A303 Sparkford to Ilchester Dualling Scheme TR010036

9.25 Responses to the Examining Authority's Second Round of Written Questions

**Responses to the Examining Authority's Second Round
of Written Questions**

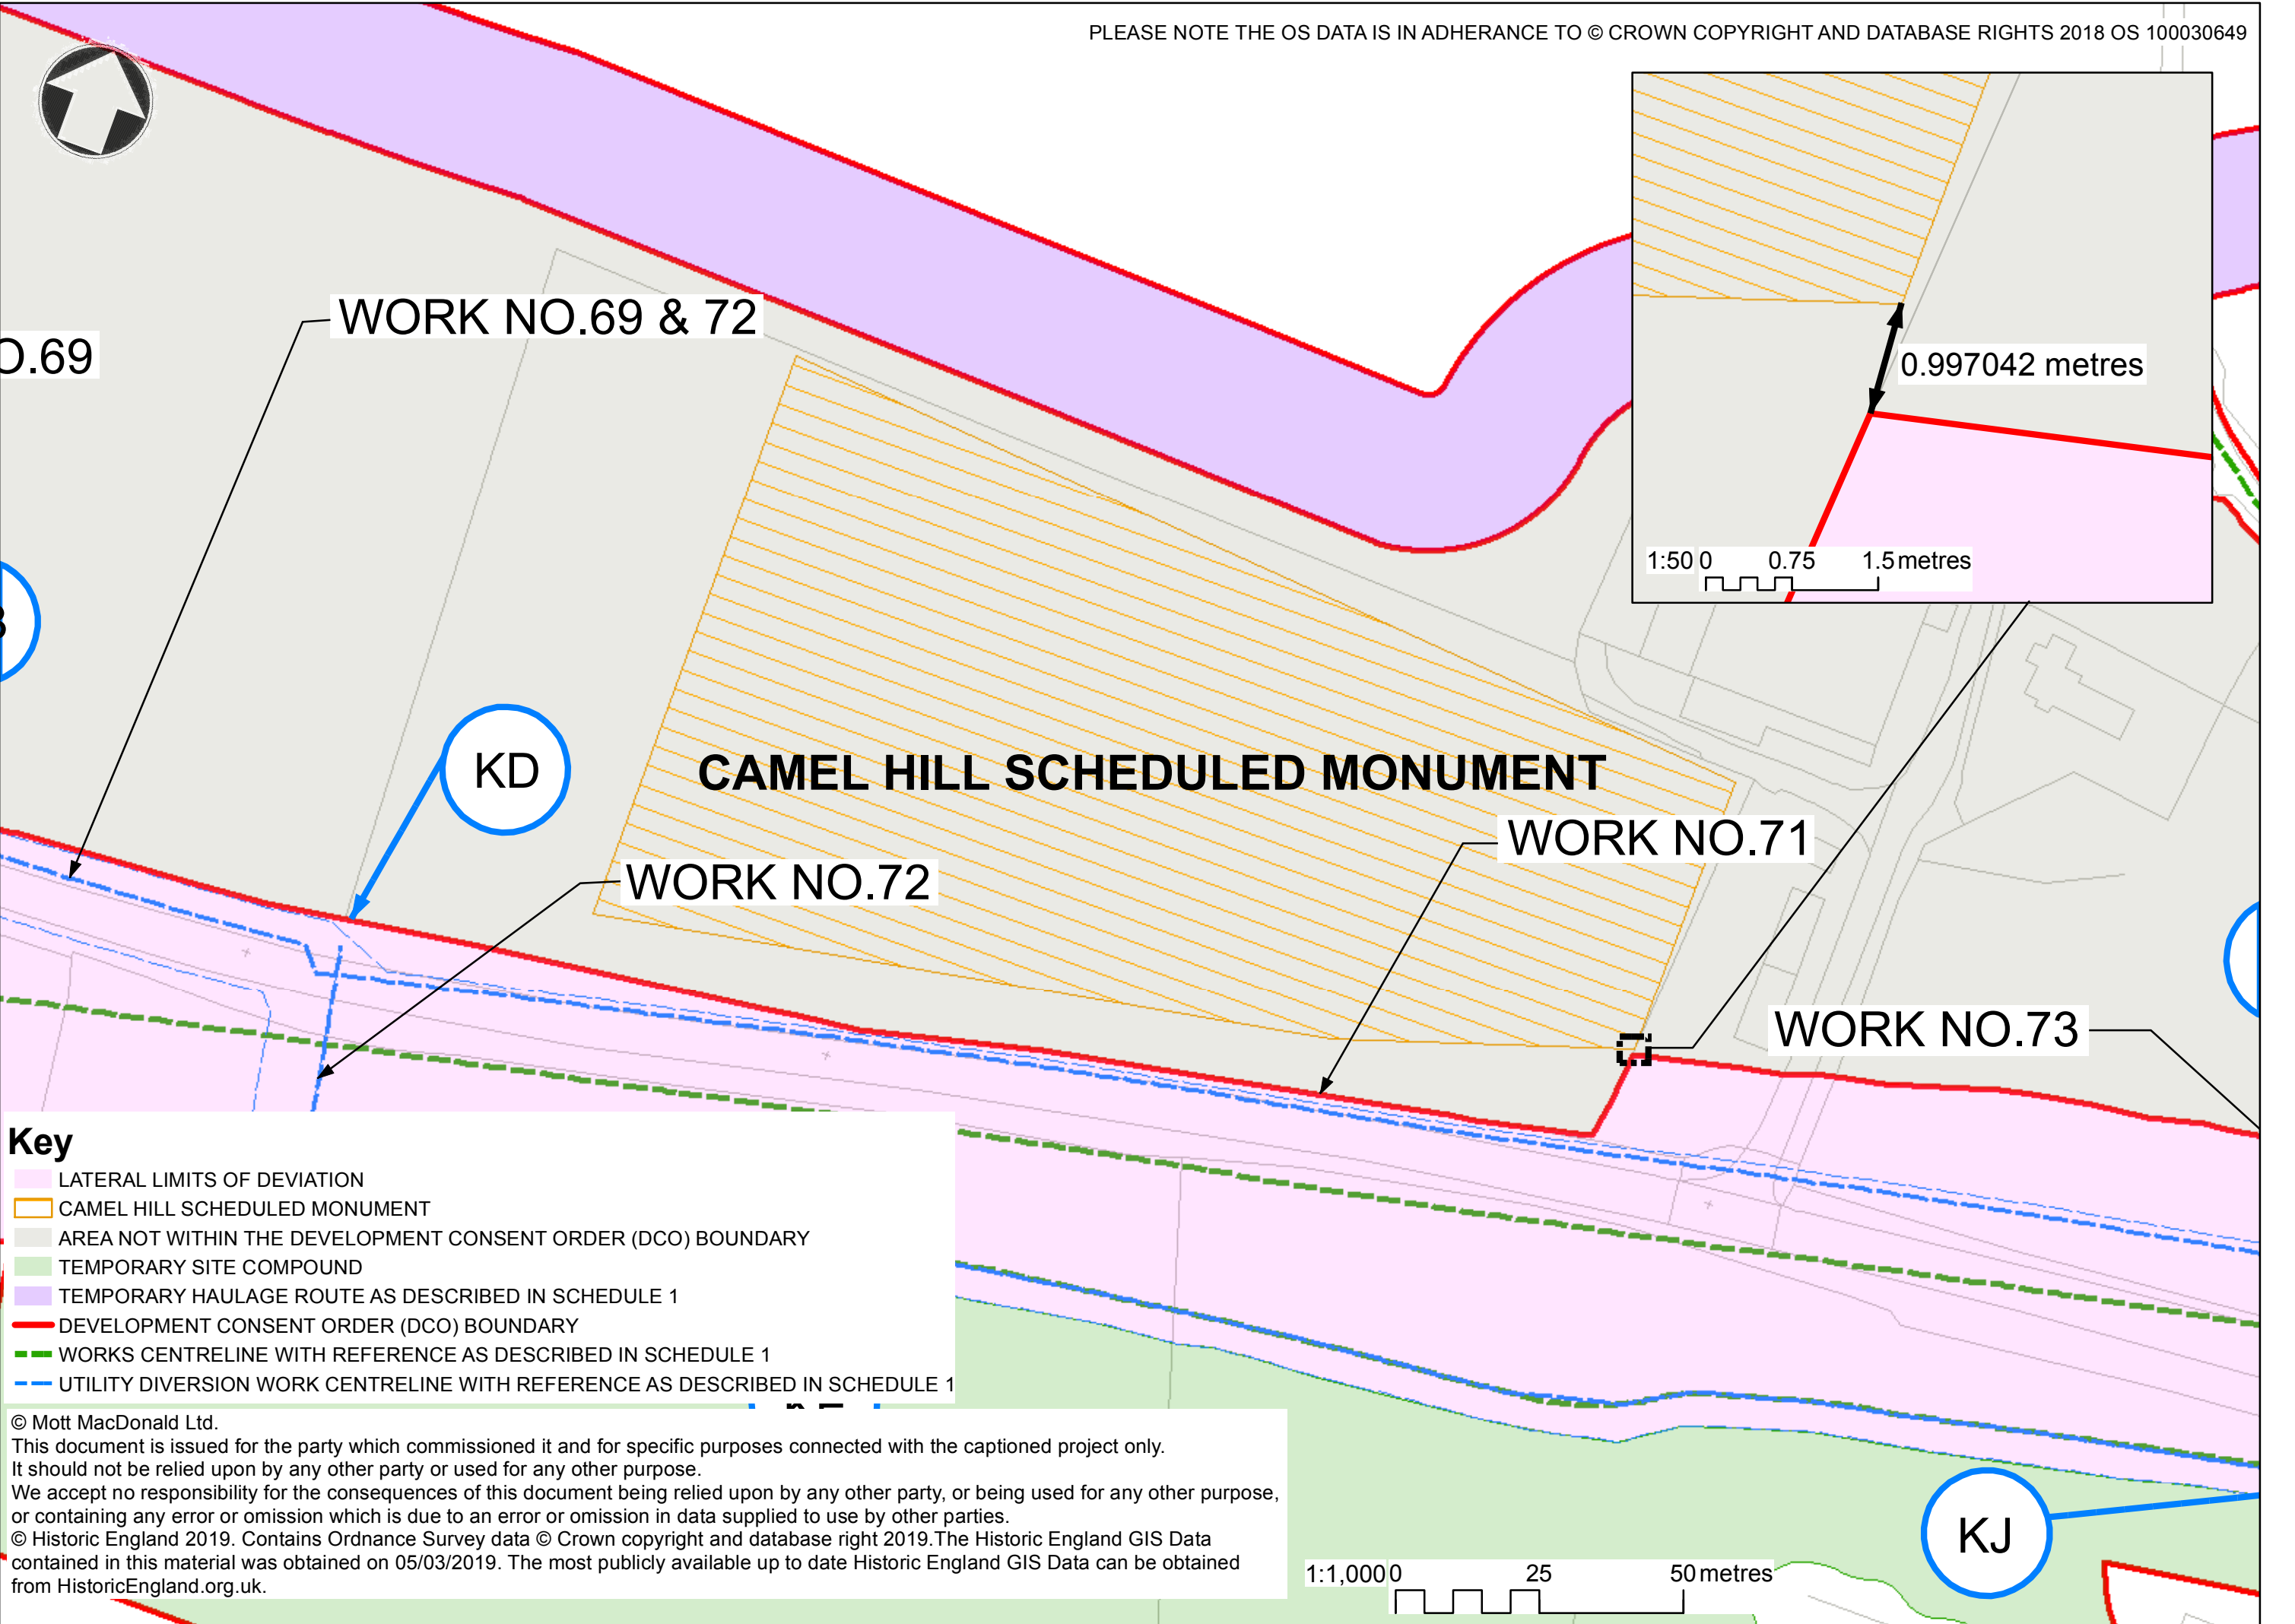
2.1.10	The Applicant	<p>Camel Hill SAM In Appendix A of the Applicant's Deadline 4 Supporting Information [REP4-018] the Applicant has provided a Wireframe Photograph.</p> <p>There may have been a misunderstanding as this only shows the existing situation not the situation in the change as at Year 1 or Year 15.</p> <p>While it may not have been possible to provide a full photomontage the ExA was expecting a net on the drawings showing the extent of the proposed works so that the effect could be assessed. Could the Applicant please provide this.</p>	<p>A photomontage to depict the change at Year 1 and Year 15, from Camel Hill Scheduled Monument (SM) has been produced and is included within Appendix A of this report.</p>
